## Report

### *Consultation on the revision of the TSI relating to accessibility for persons with disabilities and persons with reduced mobility*

## 2. Table of the change requests received and ERA answers

Figure 7 — Examples of minimum doorway position markings (without entrance steps)

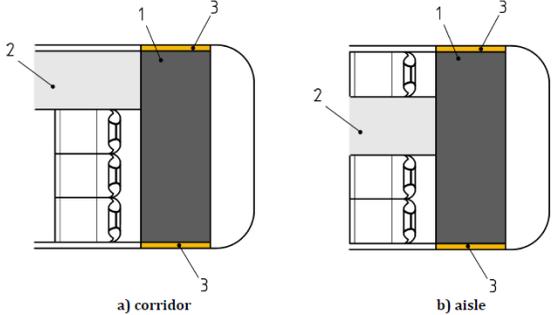
4.2.2.11.2 & 4.2.2.12.1 & 5.3.2.8 & 6.2.3.2	P	Faiveley	<p>Clause 4.2.2.11.2 (4) states that the “As a minimum the first and the last steps shall be indicated by a contrasting band with a depth of 45 mm to 55 mm extending a minimum of 80 % of the width of the steps on the top surface of the step nosing. A similar band shall indicate the front surface of the last step when entering the unit.”</p> <p>Nevertheless clause 4.2.2.11.2 (6) states that “If a step board is fitted and it is an extension of a door sill outside the vehicle, and there is no change in level between the step board and the floor of the vehicle, this shall not be considered to be a step for the purposes of this specification. A minimal drop in level, with a maximum of 60 mm, between the floor surface at door sill and that of the exterior of the vehicle, used to guide and seal the door is also permissible and shall not be considered as a step.”</p> <p>That means that sub-clause (4) related to contrasting band does not apply and that contrasting band are not required.</p> <p>Clause 4.2.2.12.1 - Movable step and bridging plate – does not require contrasting band and refers to clause 5.3.2.8 for additional requirements. Clause 5.3.2.8 - Boarding aids: movable steps and bridging plates – does not require contrasting band on movable steps and bridging plates The conclusion of these clauses is that contrasting bands are not mandatory in case the vestibule and the door sill are at the same level and that</p>	Accepted	We propose to add a reference to EN16584-1 point 5.3.9 in the application guide

contrasting band are not mandatory for movable steps and bridging plates.  
 Clause 6.2.3.2 – Step position for vehicle access and egress – which states that the “outer end of the floor at the passenger access shall be considered as a step” does not solve the problem because this requirement is clearly only valid to calculate the gap between the vehicle and the platform.  
 To clarify the requirements, our proposal is:  
 Clause 4.2.2.11.2 – add in sub-clause (4)  
 “The outer end of the floor at the passenger access shall be considered as a step for the purpose of this clause.  
 Movable steps and bridging plates shall be considered as a step for the purpose of this clause”

Note : see figures 7 and 8 of EN16584-1 below for a better understanding of the comment
